City of
Peterborough

COMMITTEE OF ADJUSTMENT

HEARING DATE: June 29, 2010

Staff Comments Re: Files: A14//10, A15/10, A16/10, A17/10, A18/10 & A19/10

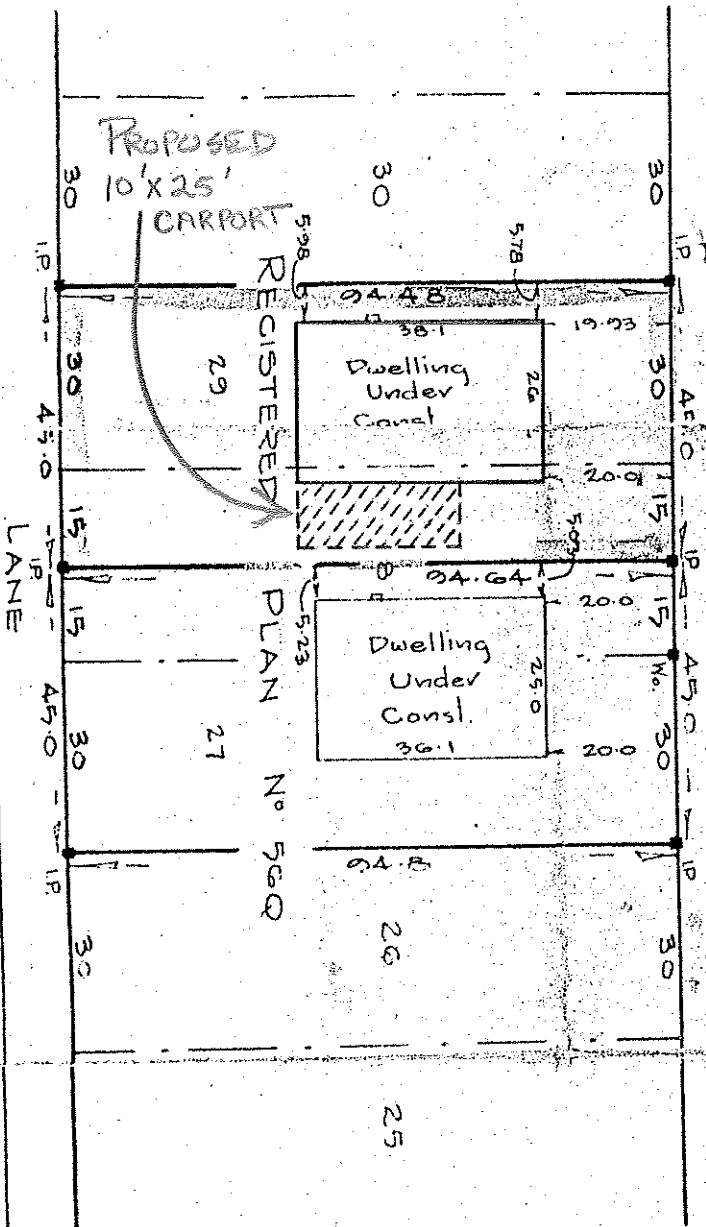
The owner would like to construct a 9.1 metre (30 ft) by 4.87 metre (16 ft), two storey addition to the rear of the 109 sq metre dwelling on the property as illustrated on the plan attached to the staff report as Exhibit A. The zoning by-law defines a side lot line as a lot line that intersects a street line. Considering the irregular configuration of the easterly side lot line, a variance is necessary to reduce the minimum building setback from the easterly “rear” lot line from 7.6 metres (25 ft) to 3.5 metres (11.48 ft).

Staff visited the property and considered the standard of development in the neighbourhood. Notwithstanding the location of a garage associated with the neighbour's property being located on the lot line, the proposed addition would be 4.5 metres (15 ft) from corner of the easterly rear lot line which is 3 metres greater than the distance that a detached garage could be located from a side lot line if the east side lot line was typical. Considering the size of the dwelling, Staff are of the opinion that the proposed addition is reasonable and impact of the variance in relation to what practically relates to the development as a side lot line, would be minor.

Subject to concerns raised by neighbouring property owners, Staff would not object to the Committee granting the variance as described.

BRAIDWOOD AVENUE

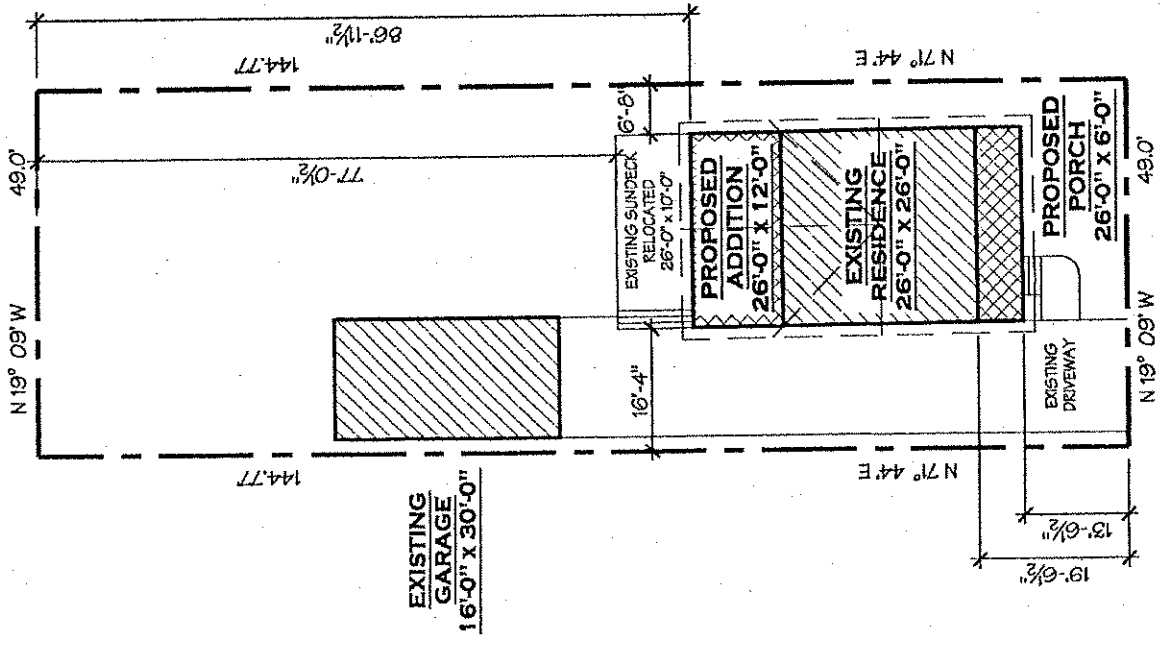
A variance is requested to reduce the minimum building setback from the east side lot line from 1.2 metres (3.93 ft) to 0.6 metres (2 ft) to permit a 3.8 metre (12.6 ft) by 7.6 metre (25 ft) carport to be attached to the east side of the dwelling.

Referring to the plan attached to the staff report as Exhibit B, the survey indicates that there is enough space between the dwelling and the lot line to establish a carport with the uprights located 0.6 metres from the lot line and room for the eaves overhang. The Survey also illustrates that the dwelling on the adjacent lot is located 1.8 metres (6ft) from the lot providing adequate space separation between structures.

Considering the established standard of development in the neighbourhood, Staff is of the opinion that the proposal offers a reasonable separation between buildings and the impact of the development as a result of the variance would be minor.

Subject to concerns raised by neighbouring property owners, Staff would not object to the Committee granting the variance as described.
